Re: ***Winsome Filing No. 3 PCM Certification Letter
El Paso County, Colorado***

This letter serves as the certification for Winsome Filing No. 3, El Paso County, CO consistent with El Paso County Engineering Manual ("ECM") Section 5.10.6.B, which states that Engineering Record Drawings shall be accompanied by a certification letter from the Engineer of Record which shall state that facilities constructed provide the required storage volume, meet the required release rates, the stage areas, elevations and outlet dimensions. Based upon this information and information gathered during periodic site visits to the site during significant/key phases of the infrastructure installation, Kimley-Horn & Associates, Inc. is of the opinion that the work performed under the County Permit, per Section 5.10.6.B of the ECM, have been constructed in general compliance with the approved Construction Plans as filed with the County dated April 28, 2023 and approved by El Paso County on May 31, 2023.

WINSOME FILING 3
POND 1 AND HB5 FINAL ASBUILT
FIELD DATA COLLECTED THROUGH 4-03-25

4 ORIFICE PLATE AND TRASH RACK DETAIL

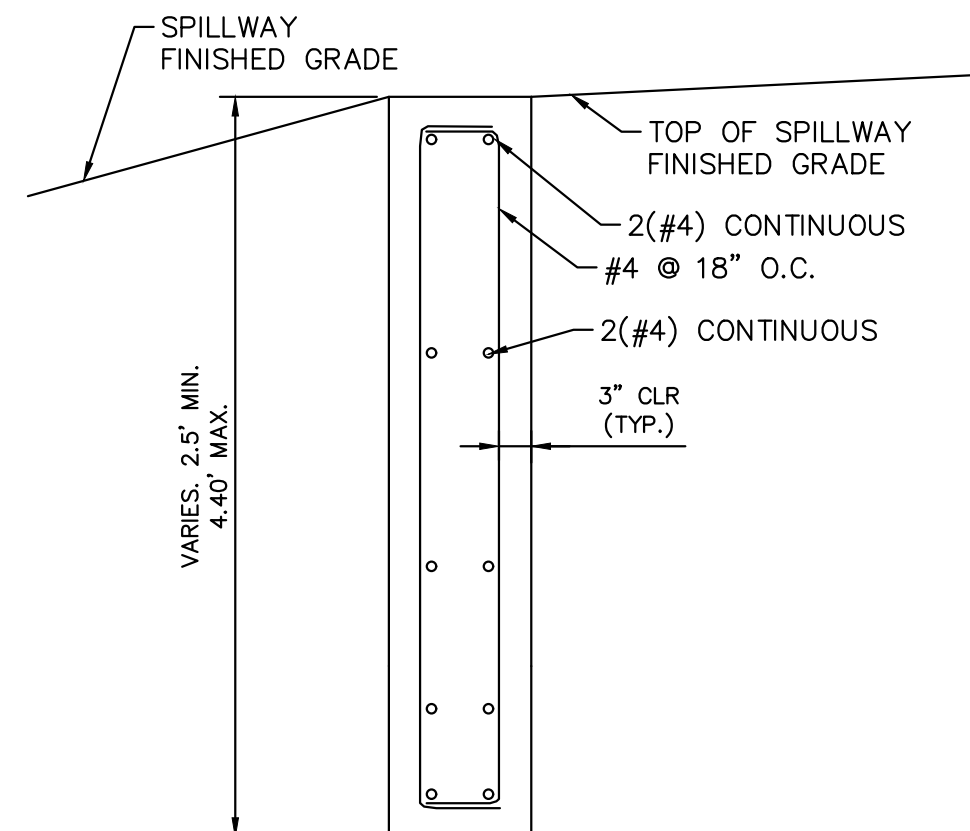
1. WELL-SCREEN TRASH RACKS SHALL BE STAINLESS STEEL AND SHALL BE ATTACHED BY INTERMITTENT WELDS ALONG THE EDGE OF THE MOUNTING FRAME.
 2. BAR GATE TRASH RACKS SHALL BE ALUMINUM AND SHALL BE BOLTED USING STAINLESS STEEL HARDWARE.
- GAPS IN TRASH RACK WERE INSTALLED HORIZONTALLY, RATHER THAN VERTICALLY AS SHOWN IN THE PLAN

11 ROCK CHUTE #4 PROFILE- CROSS SECTION 2
N.T.S.

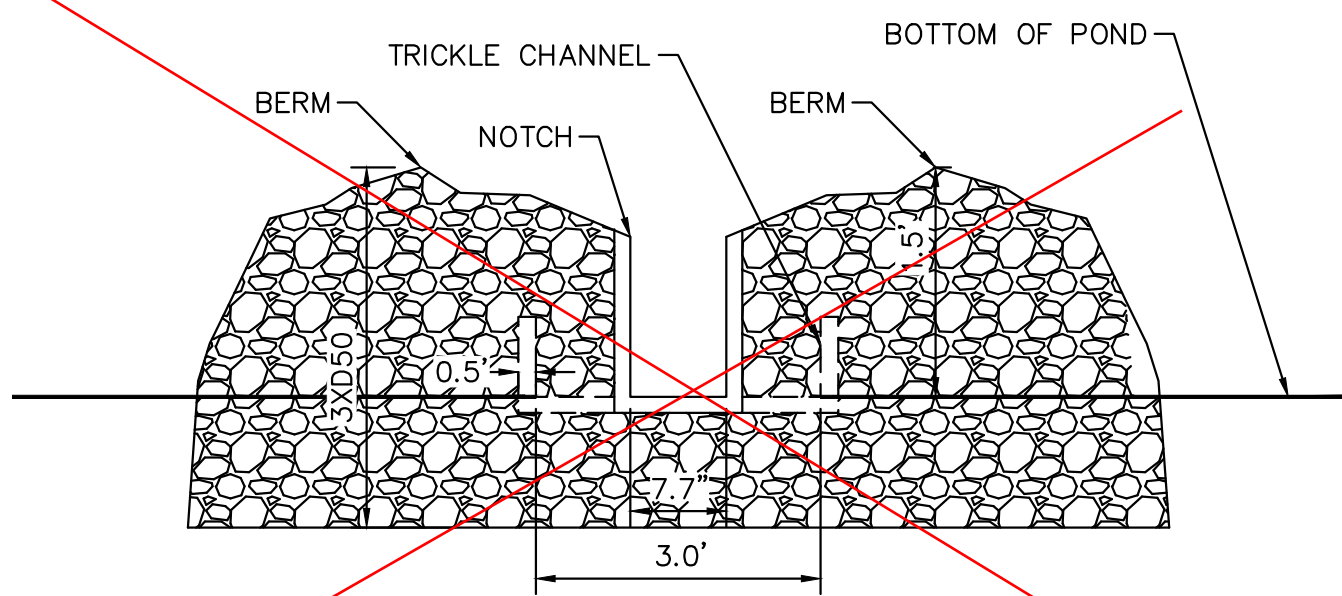
NOTCH REPLACED
WITH PVC PIPE PER
FIELD CHANGE.
VERIFIED WITH EPC
STORMWATER PIROW
TO FIELD CHANGE

4 ORIFICE PLATE AND TRASH RACK DETAIL

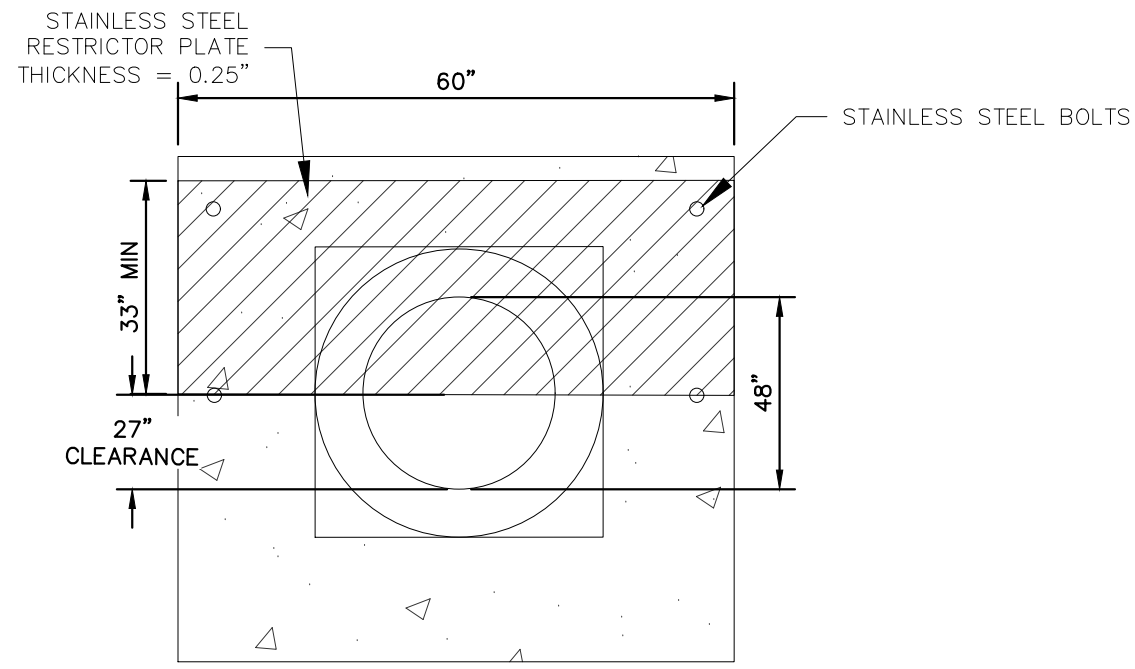
GAPS IN TRASH RACK WERE INSTALLED HORIZONTALLY, RATHER THAN VERTICALLY AS SHOWN IN THE PLAN

8 EMERGENCY SPILLWAY DETAILS

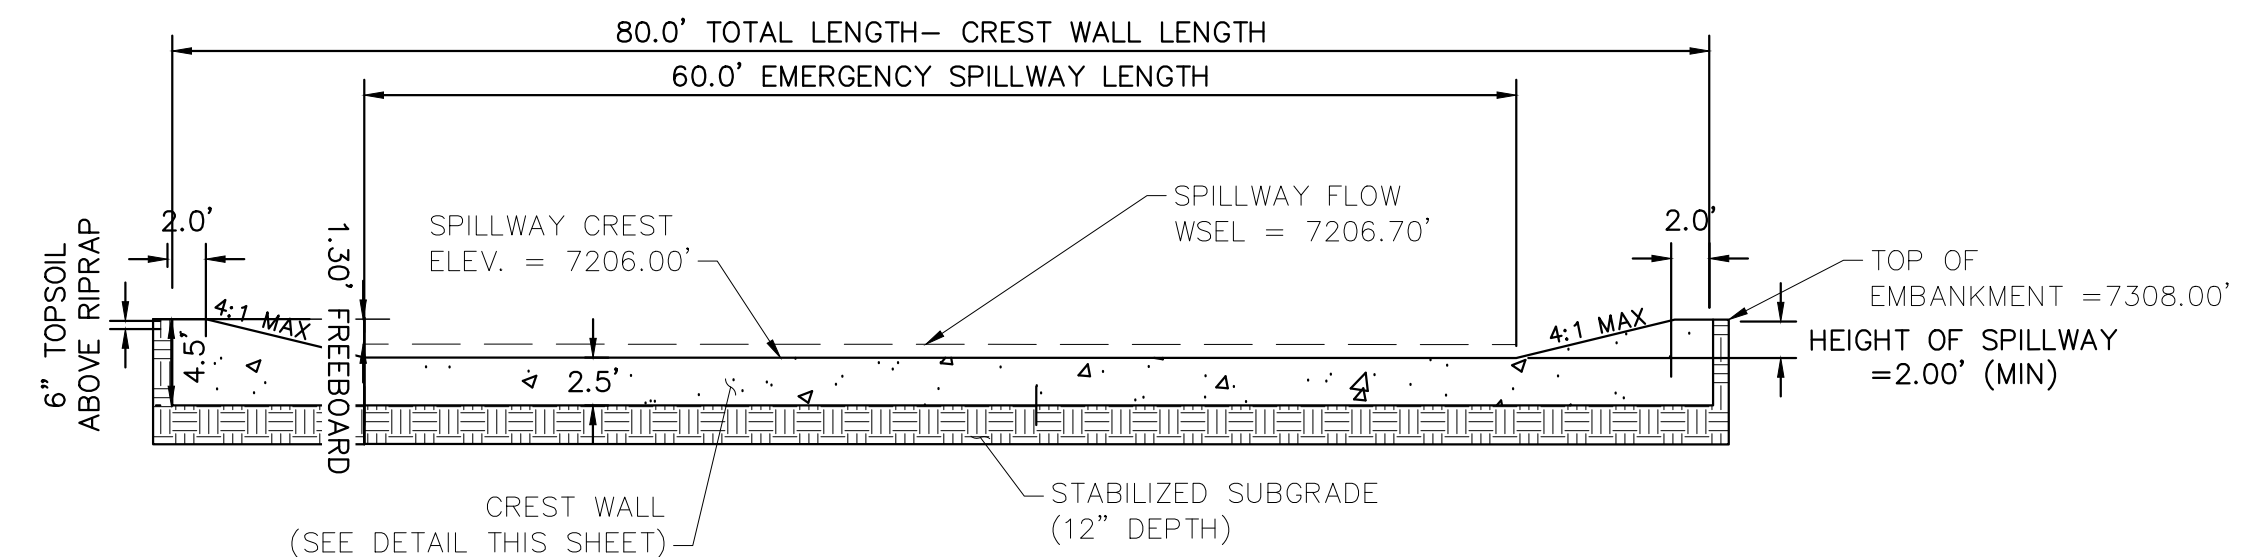
EMERGENCY SPILLWAY ELEVATIONS CONSTRUCTED PER PLAN

EMERGENCY SPILLWAY ELEVATIONS CONSTRUCTED PER PLAN

12 **ROCK CHUTE #6 NOTCH PROFILE**
N.T.S.

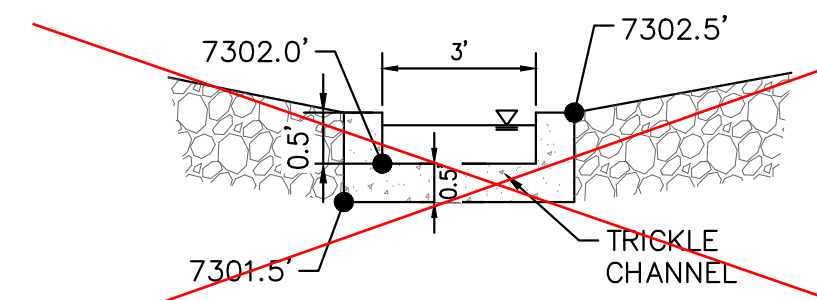
NOTCH REPLACED
WITH PVC PIPE PER
FIELD CHANGE.
VERIFIED WITH EPC
STORMWATER PIOR
TO FIELD CHANGE

4 ORIFICE PLATE AND TRASH RACK DETAIL

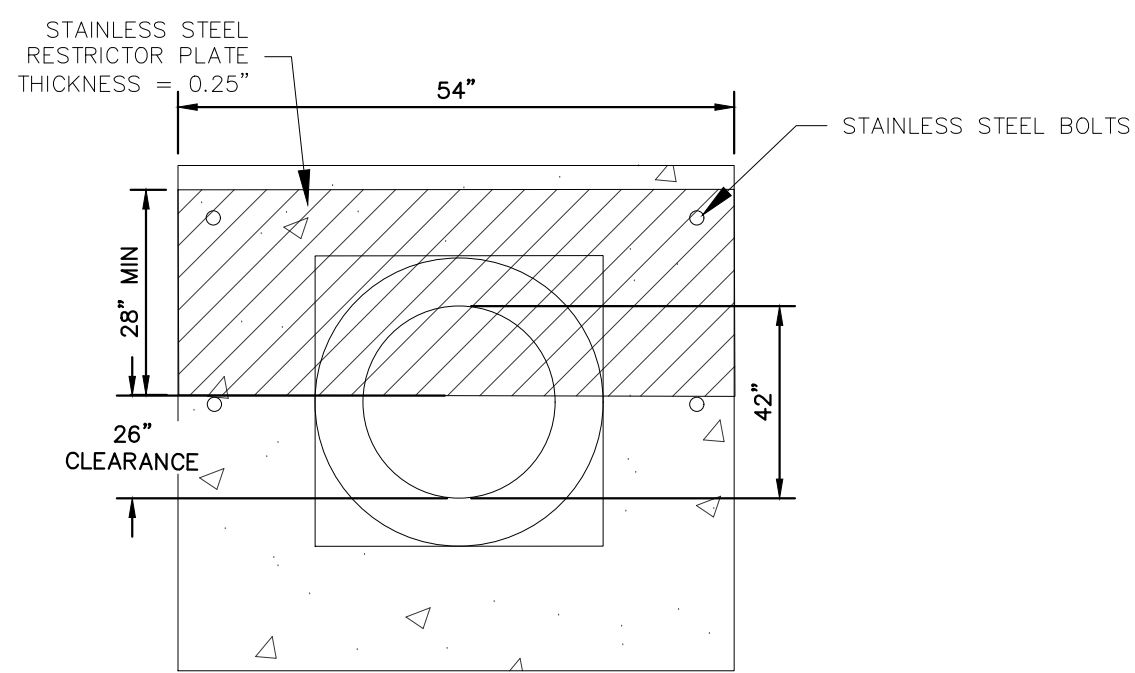
GAPS IN TRASH RACK WERE INSTALLED HORIZONTALLY, RATHER THAN VERTICALLY AS SHOWN IN THE PLAN

B **SECTION B**
N.T.S.

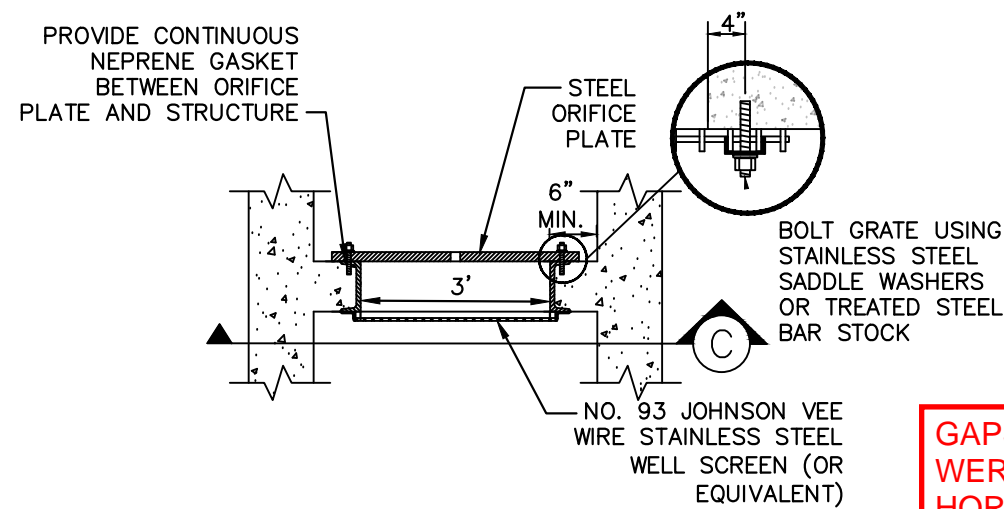
GAPS IN TRASH RACK WERE INSTALLED HORIZONTALLY, RATHER THAN VERTICALLY AS SHOWN IN THE PLAN
